**GS# 104-215 Jones Hall Interior Renovations  
Mississippi University for Women**

Addendum No. 2

SHEET **E009**

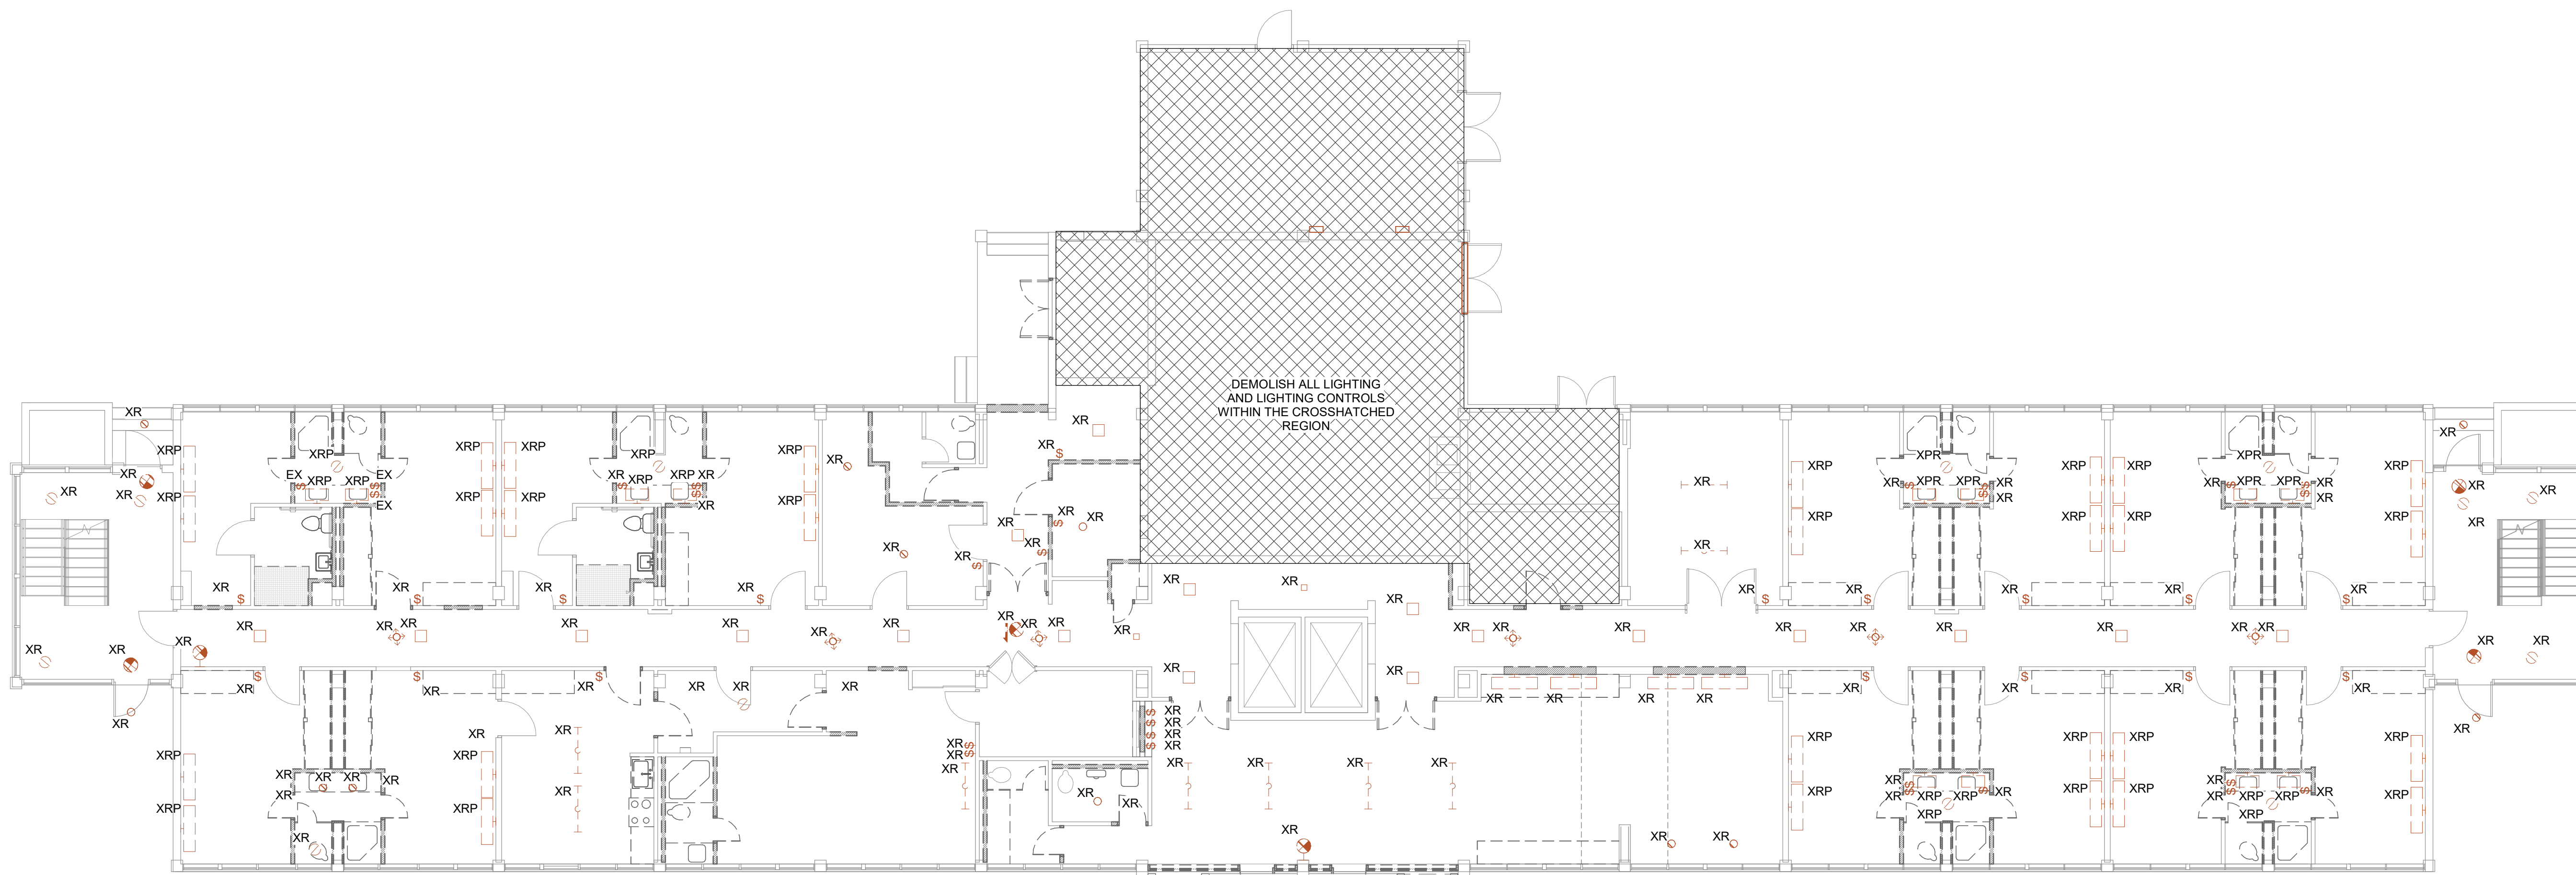
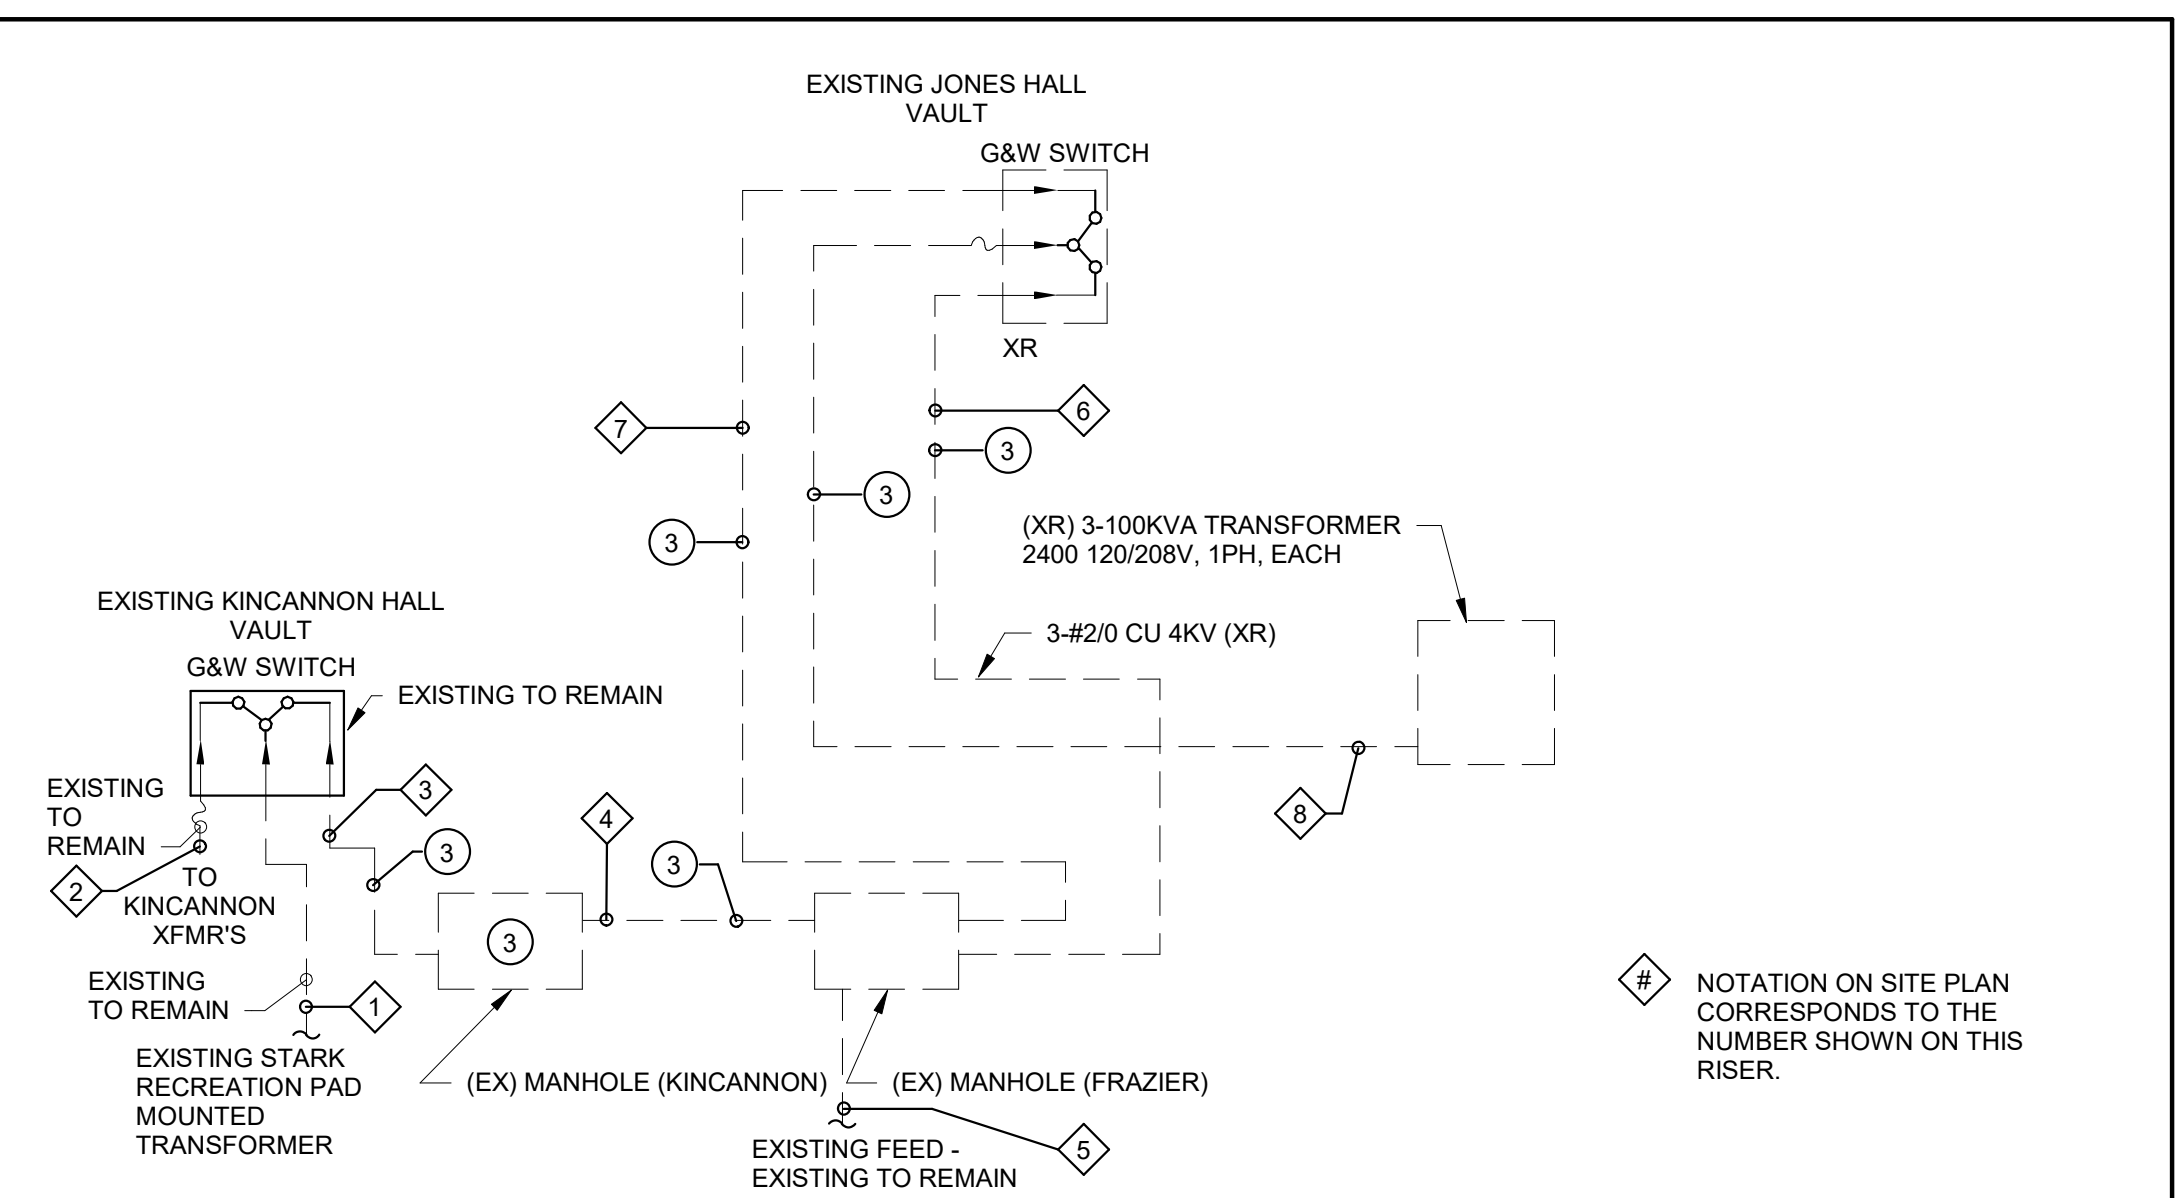
- s. Revise Sheet E009 and replace with attached Sheet E009. Revisions include providing the partial riser diagram callout to correspond with the notation on the site plan. Edited site plan notes to coordinate high voltage service with Columbus Power and Light.

SHEET **E101**

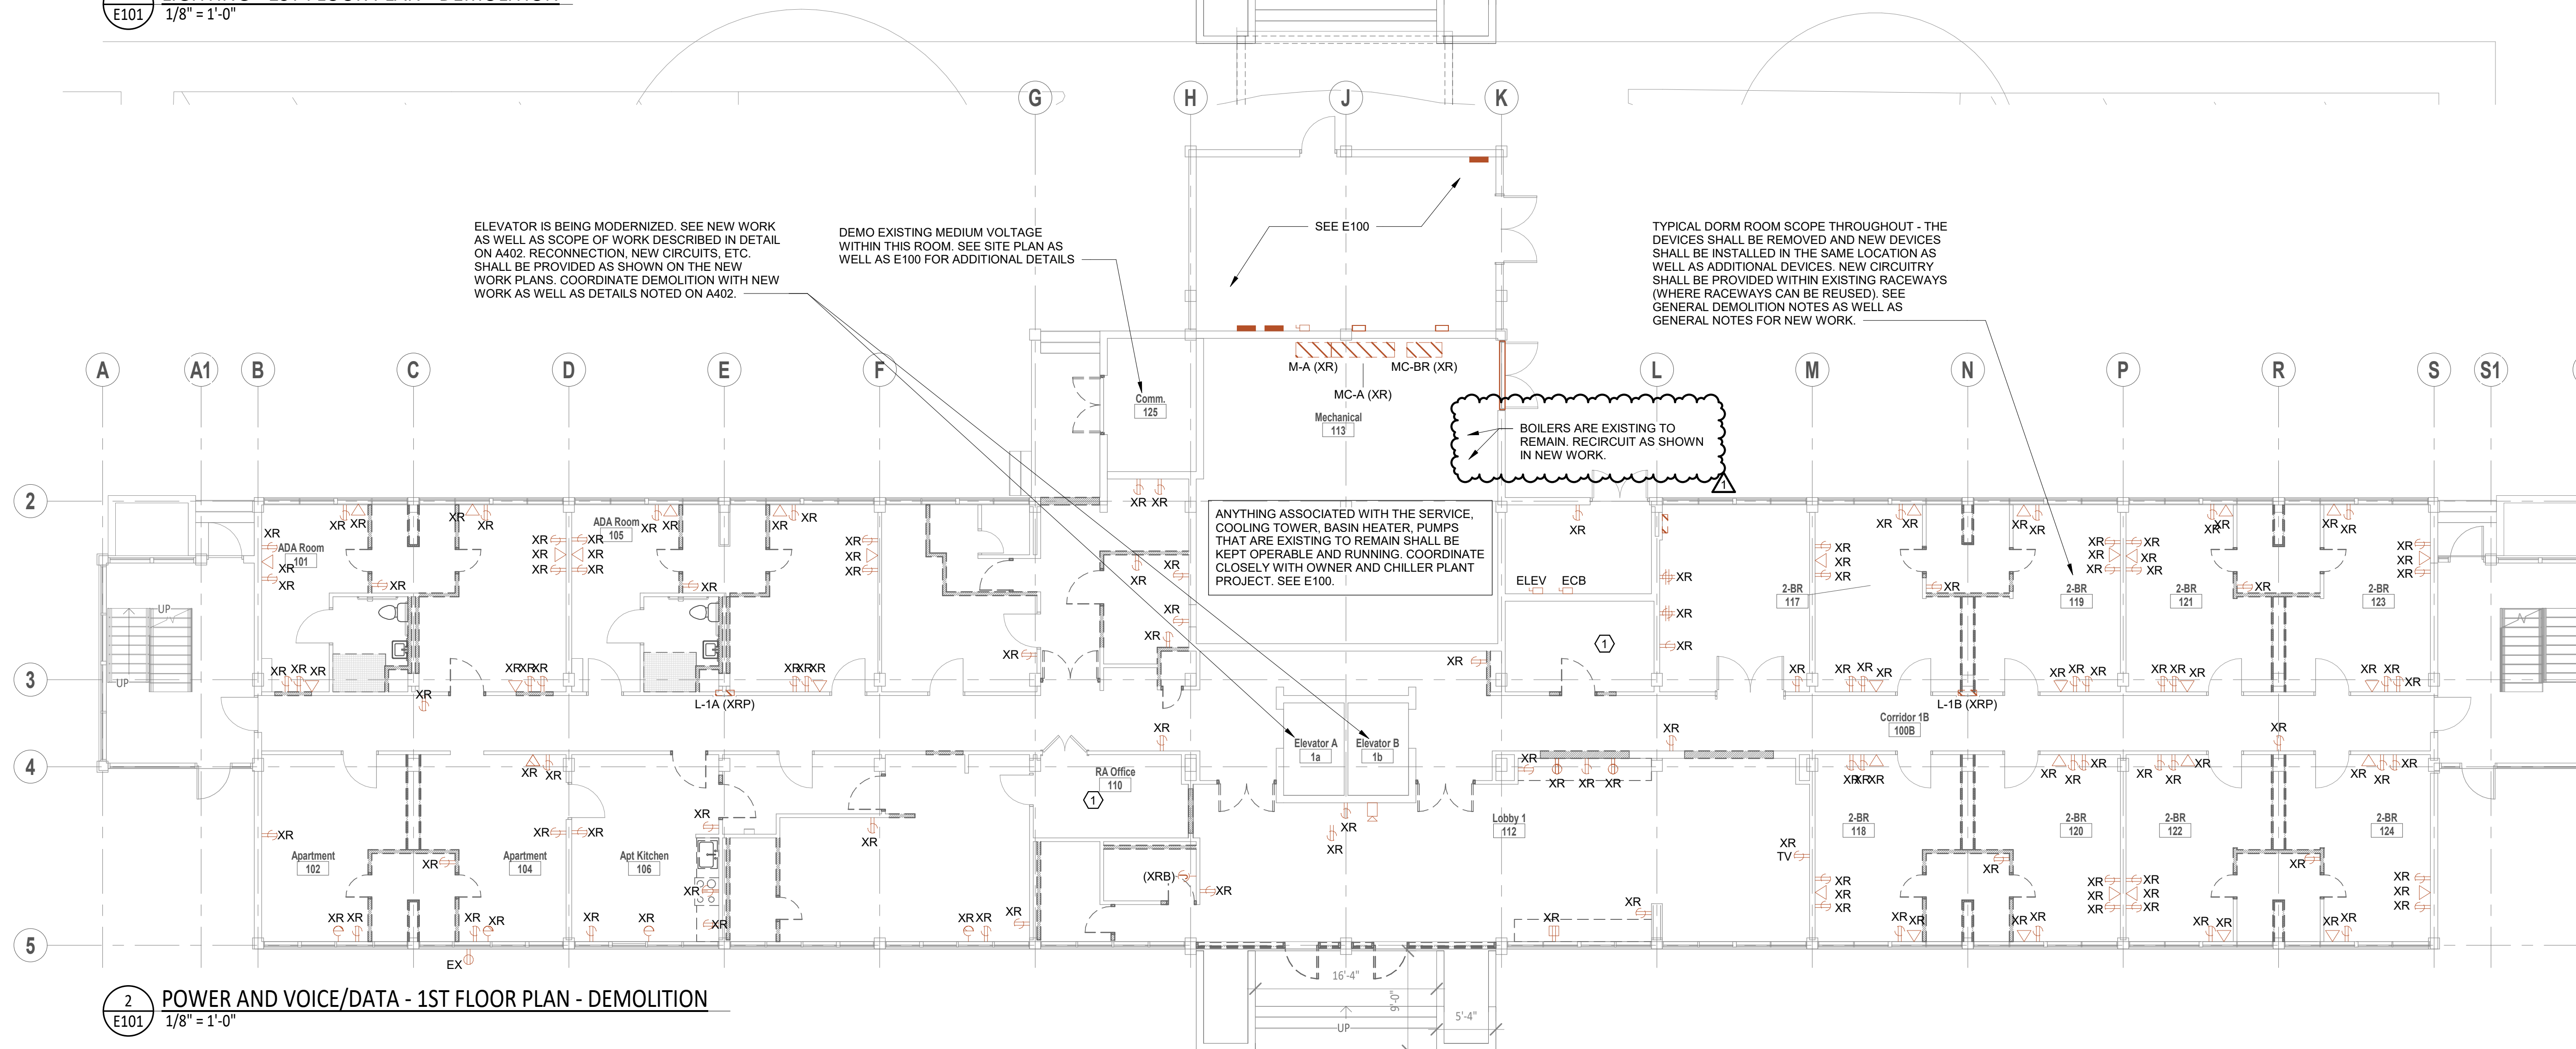
- t. Revise Sheet E101 and replace with attached Sheet E101. Revisions include adding a note to show existing boiler location.
- u. Revise Sheet E301 and replace with attached Sheet E301. Revisions include adding WAP devices to each ADA room. GFI breakers show on plan for vending machines and washer/dryers in Vestibule 111 and Laundry 116. Data device added to RA Office 110. Convenience receptacles added to the front exterior of the building.
